RHODE ISLAND DEPARTMENT OF TRANSPORTATION

**Horton Farm Bridge No. 472**

**NOTICE TO PROSPECTIVE BIDDERS**

ADDENDUM NO. 4    Prospective bidders and all concerned are hereby notified of the following changes in the Plans, Specifications, Proposal and Distribution of Quantities for this contract. These changes shall be incorporated in the Plans, Specifications, Proposal and Distribution of Quantities, and shall become an integral part of the Contract Documents.

1. Pages JS-25A thru JS-25G

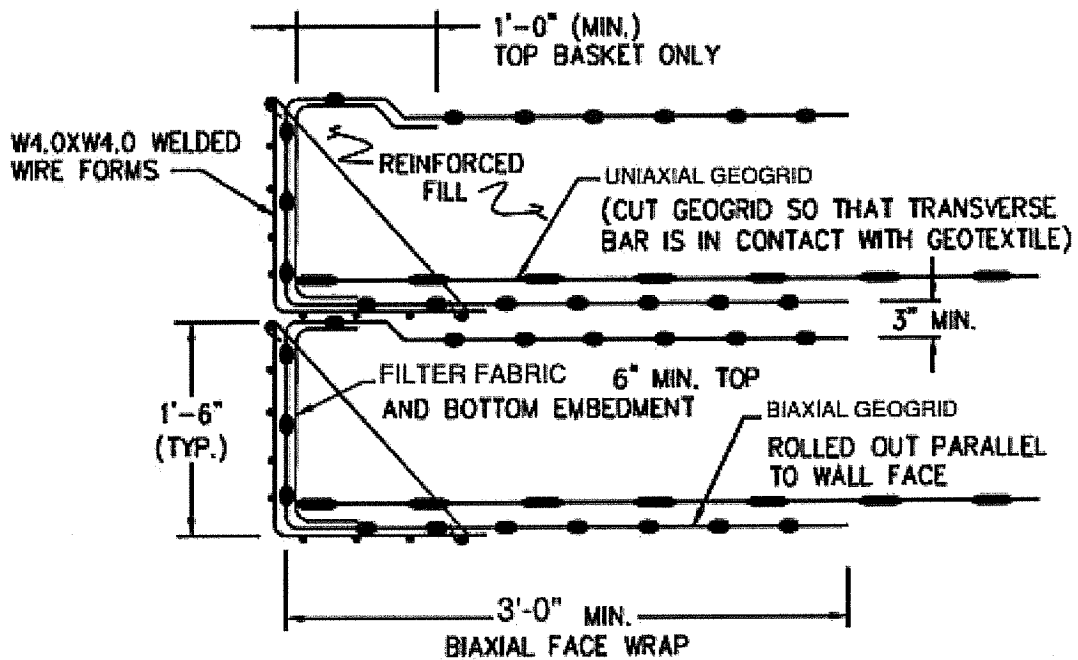
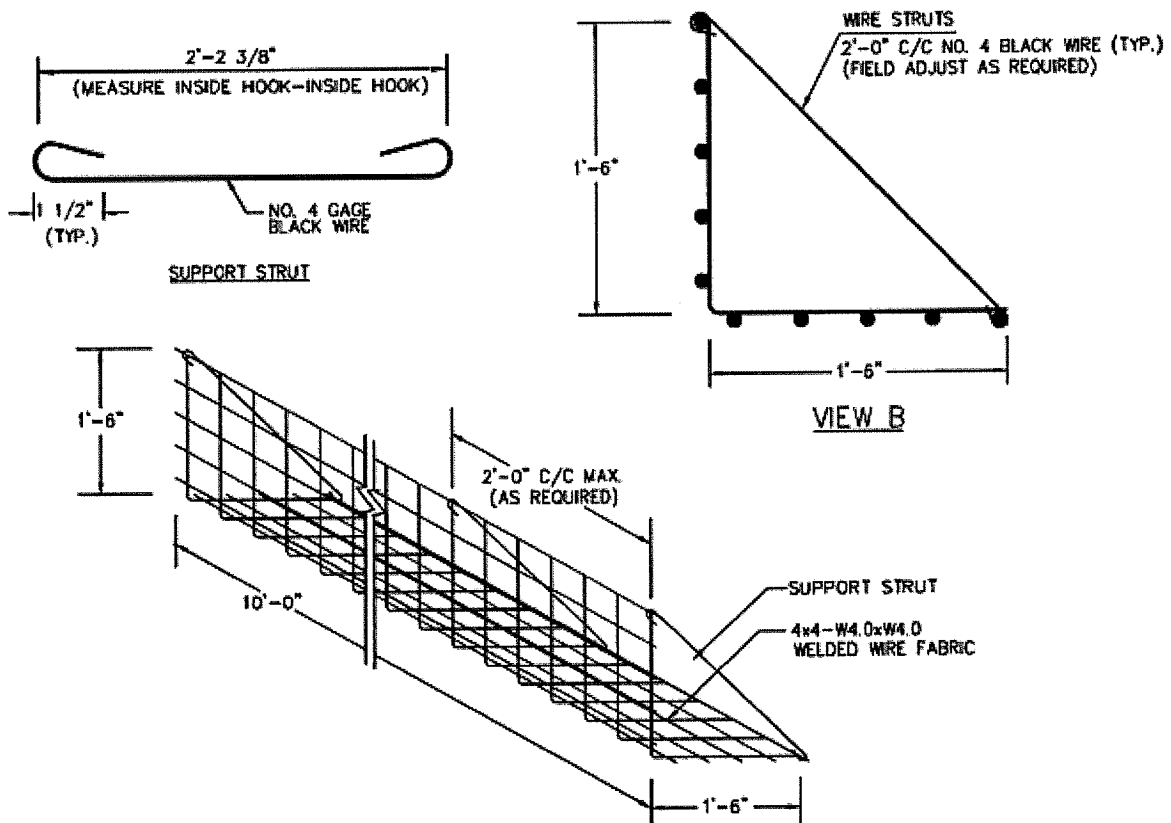
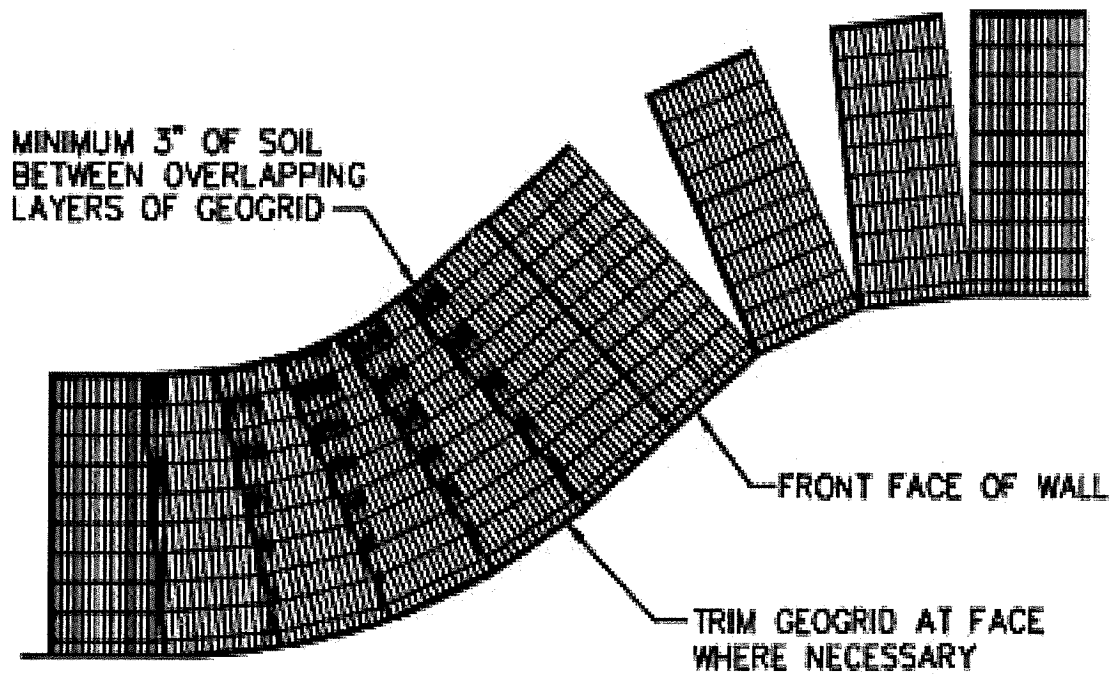
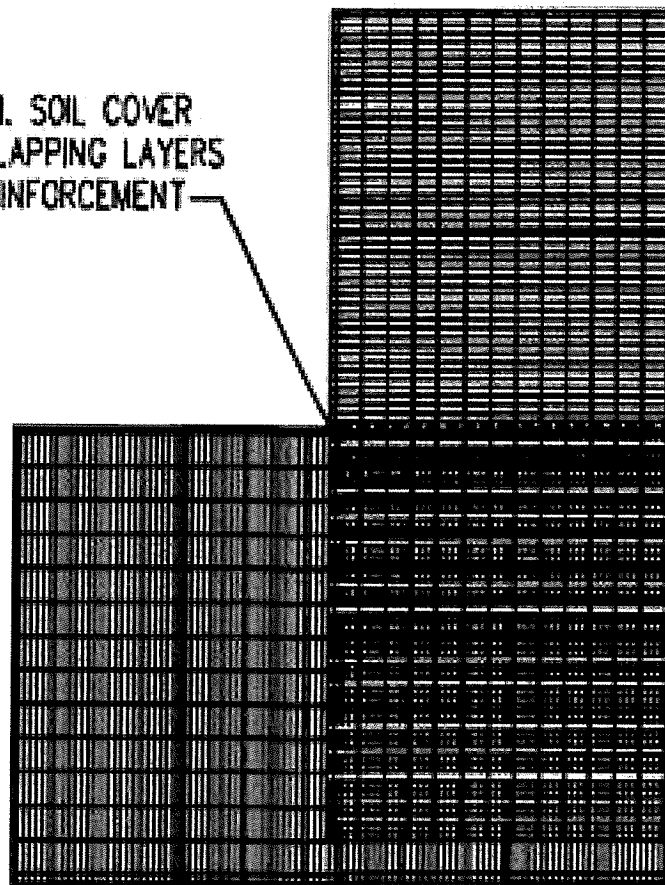
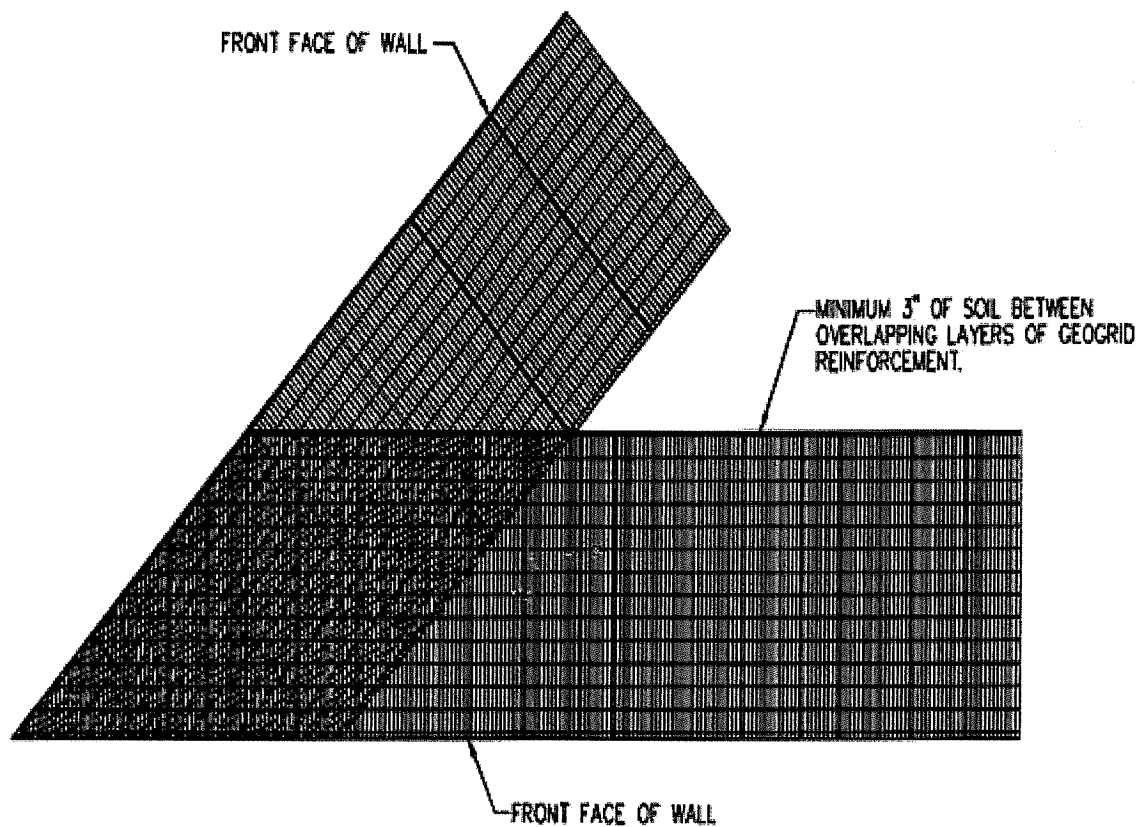
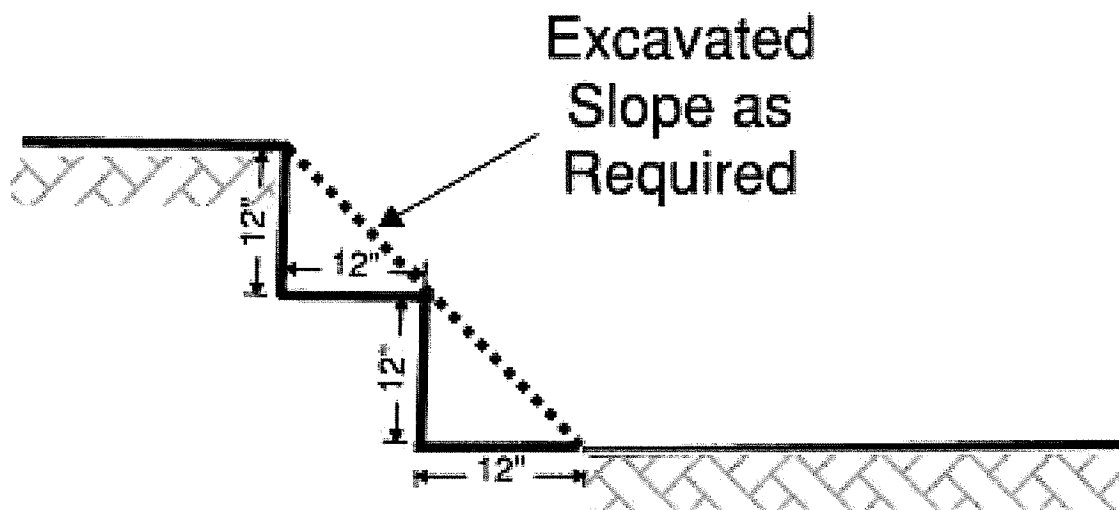
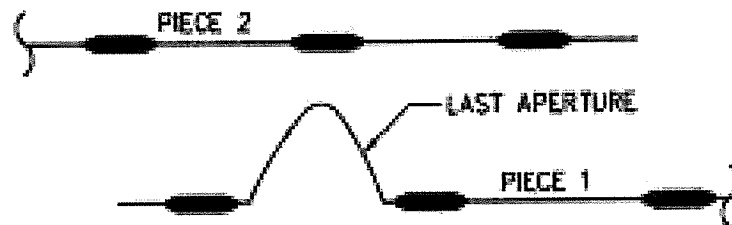
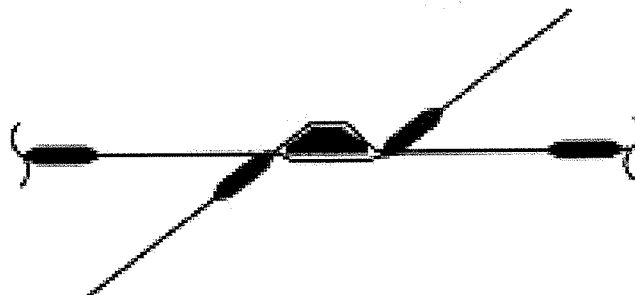
Insert pages JS-25A thru JS-25G attached to this Addendum No. 4. Details for the geogrid have been added.
